Witchita Falls LE- ADA Evaluation

LE- Witchita Falls TX, ADA Evaluation
4822 Kemp Blvd Suite 1300
Wichita Falls, TX 76308
Accessibility Evaluation
Inspection Date: 03/20/2023
Inspectors: Christopher Meza

Report Date: 01/15/2024

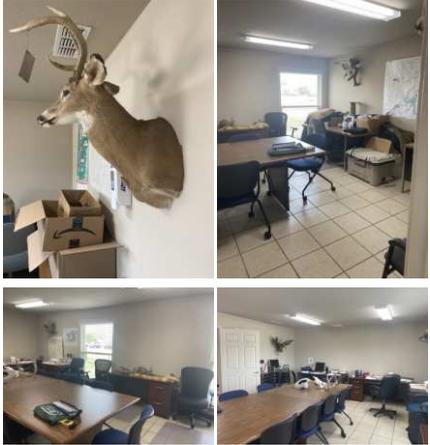
Finding Number	Area Description	Finding	As Built	Recommendation	Citation	Photos	Figure
2	Exterior of Property (Public): Parking Lot (2 Spaces) Both Unlabeled - Unlabeled Stall (R) Side	The van stall is missing a sign identifying it as a van accessible stall. Parking space identification signs shall include the International Symbol of Accessibility. Signs identifying van parking spaces shall contain the designation "van accessible."	Accessible parking stall missing designated signage. Both accessible parking stalls serving TPWD LE office meet dimensions to be designated as van parking.	https://www.access-board.gov/ada/#ada-502_6	2012 TAS Section: 502.6 2010 ADAS Section: 502.6		
3	Exterior of Property (Public): Parking Lot (2 Spaces) Both Unlabeled - Access Aisle (Shared)	The access aisle contains loose gravel and/or surface materials that do not provide for a stable, firm slip resistant surface. Parking spaces and access aisles serving them shall comply with floor or ground surface requirements. The ground surface shall be stable, firm, and slip resistant. Access aisles shall be at the same level as the parking spaces they serve. Changes in level, slopes exceeding 1:48, and detectable warnings shall not be permitted.	There is a large crack in access aisle decreasing access.	https://www.access-board.gov/ada/#ada-302_3 https://www.access-board.gov/ada/#ada-502_4	2012 TAS Section: 502.4 2010 ADAS Section: 502.4

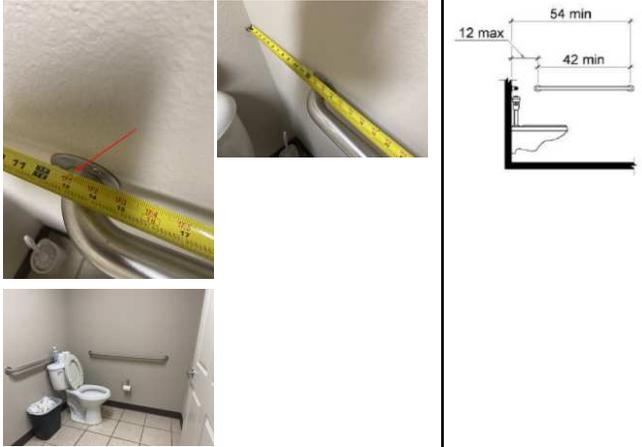
Finding Number	Area Description	Finding	As Built	Recommendation	Citation	Photos	Figure
6	First Floor Main Building LOBBY (Public): Lobby Area	The element is not accessible because the operable parts are not within the required reach range. Operable parts on accessible elements, accessible routes, and in accessible rooms and spaces shall comply with requirements for operable parts. The requirements include complying with a clear floor space, reach range, and operation.	Top tier pamphlets look to be out of reach range, need verification or alternate way of providing info.	https://www.access-board.gov/ada/#ada-205_1	2012 TAS Section: 205.1 2010 ADAS Section: 205.1
